FAX TRANSMISSIONDATE: 15 DEC '95 PAGE 1 OF 5COMPANY: ROYAL OAK MINES OUR FILE # 785ATTN: ERIC MADSENFAX: 403-669-9424FROM: LEON BRANICKIRE: RADIAL BRICK CHIMNEY.

Re: Approx. 150' x 9'-0" Radial Brick Chimney - Roaster

On September 16, 1985, we carried out an external inspection of the above subject chimney. Listed below is our findings illustrated with photographs.

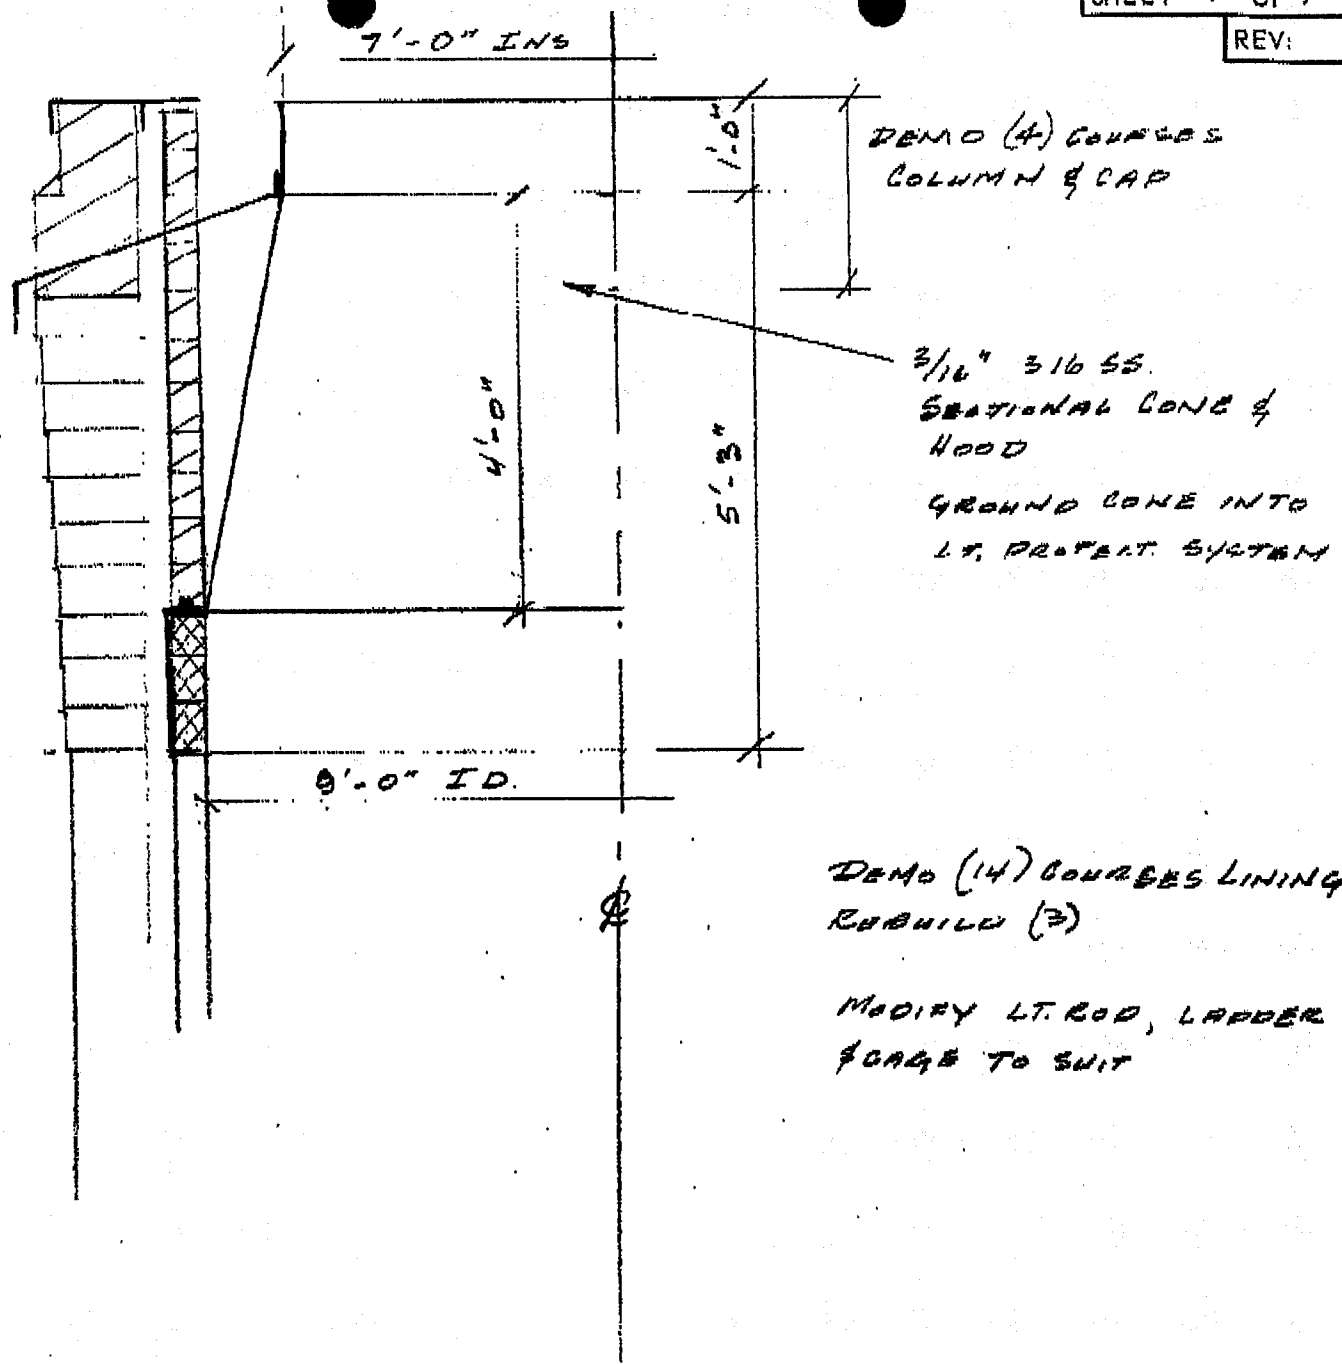
6. Place a reducing cone, 5' high, as shown on the enclosed sketch (polygon sections to be flanged and bolted together). Cone, anchors and bolts made of 316 stainless steel.

We have set the inside dimension of the cone to be 7'-0"; however, this can be adjusted to meet your specific requirements.
